**ADDENDUM NO. 4**

Notice to All Persons and Firms Proposing  
to Submit a Bid or Furnish Materials for  
Allen Road Bridge No. 329  
St. Louis County Project No. CR-1274  
Federal Project No. STP-4900(634)

ALLEN ROAD  
BRIDGE NO. 329  
OVER UNION PACIFIC RR  
MSE WALL GENERAL  
NOTES AND MSE WALL  
NO. 1 AND NO. 2

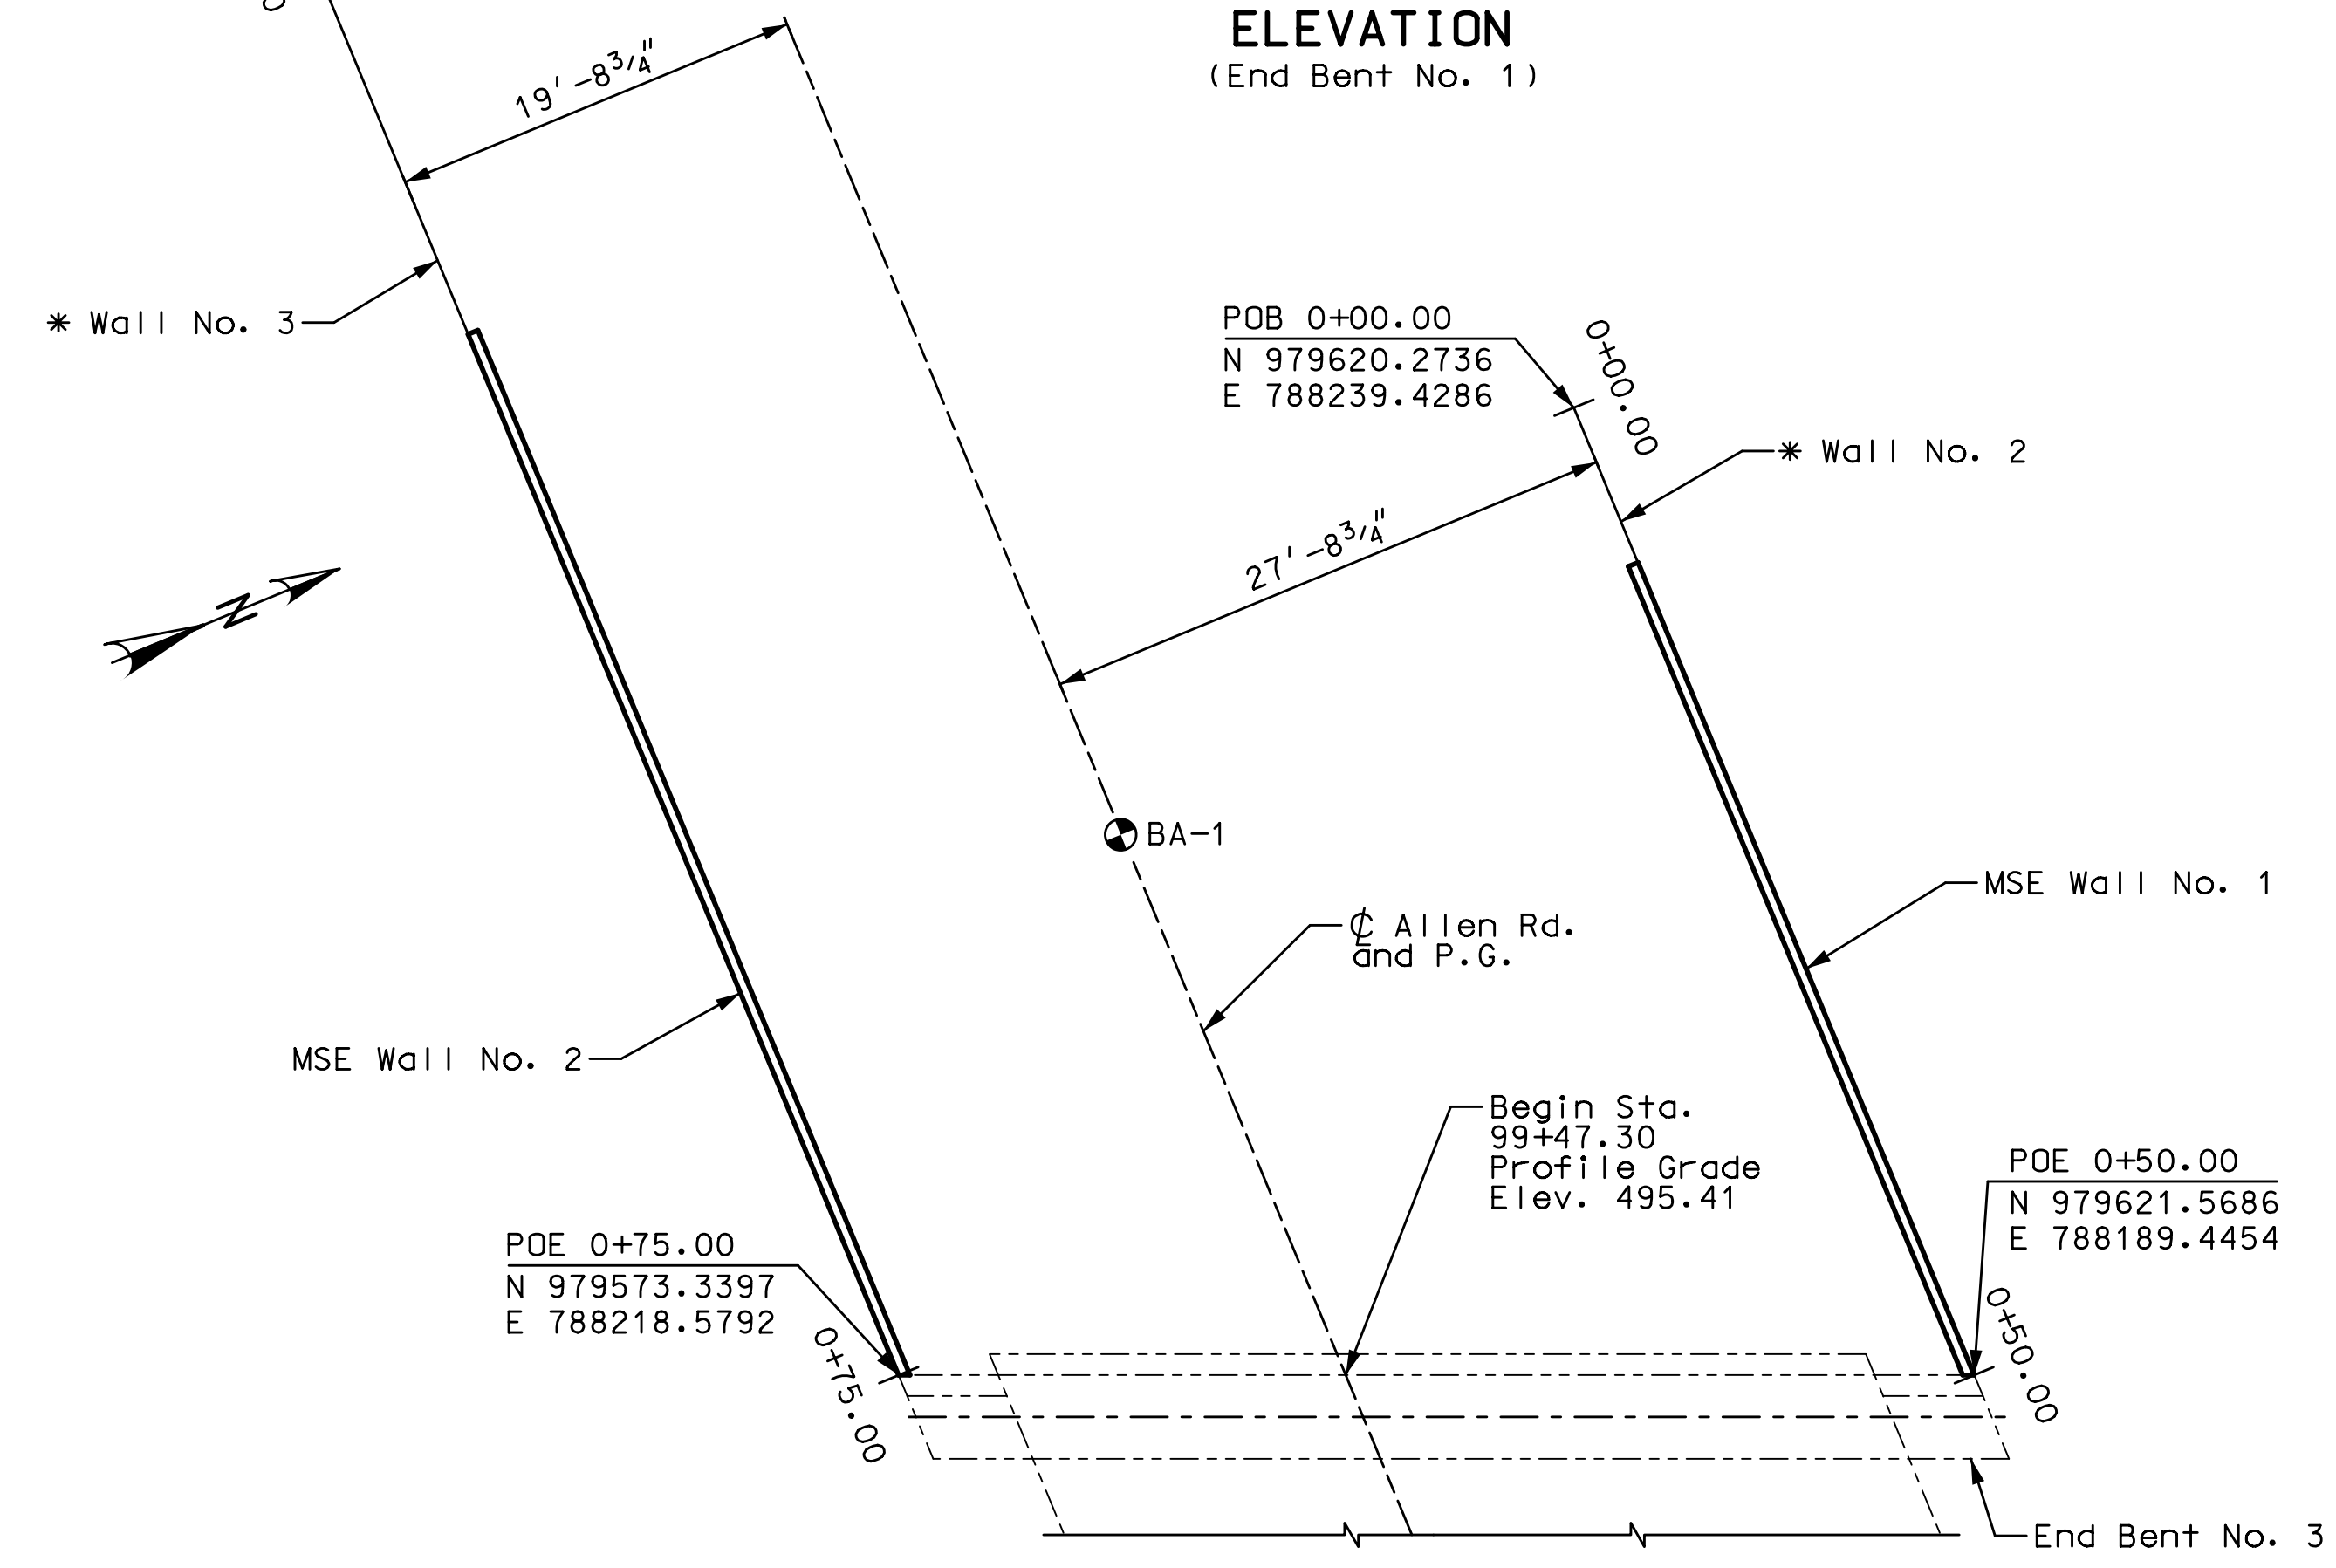
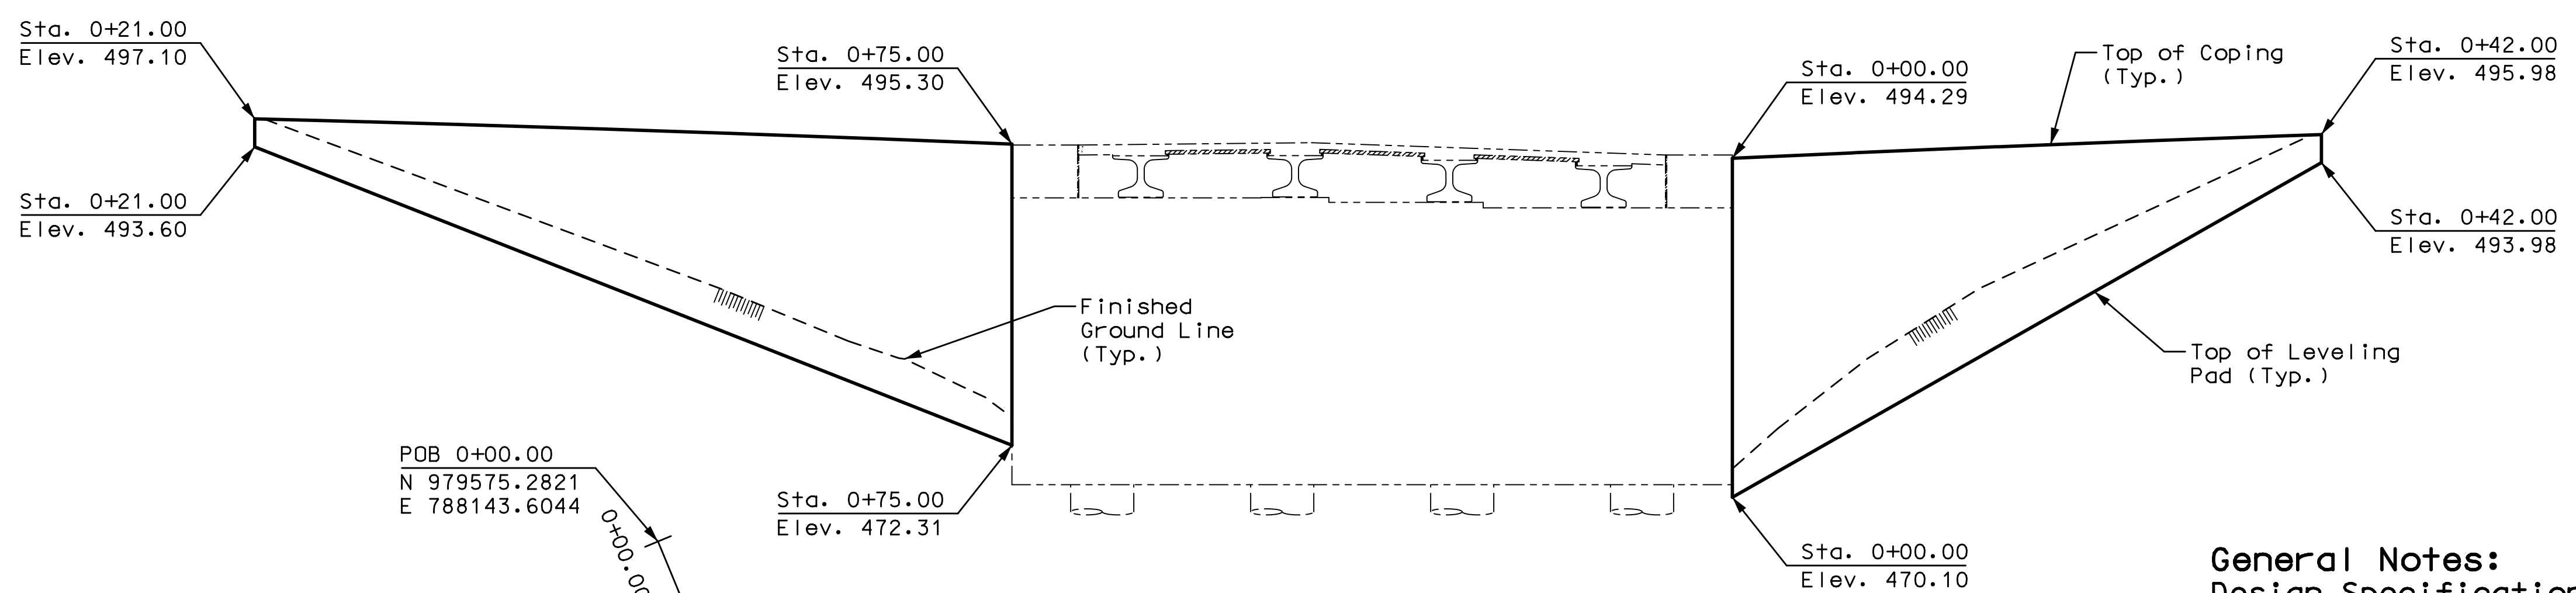
**REMOVE AND REPLACE** the existing plan sheet 82 of 84 with the attached plan sheet. This revised plan sheet updates the allowable bearing pressure for use in the design of the MSE walls.

REV	DATE	BY	APP	DESCRIPTION
1	08/20/19	MM	JEF	Addendum 4 - Value Revised

The allowable bearing pressure for unimproved ground **2.0** ksf.
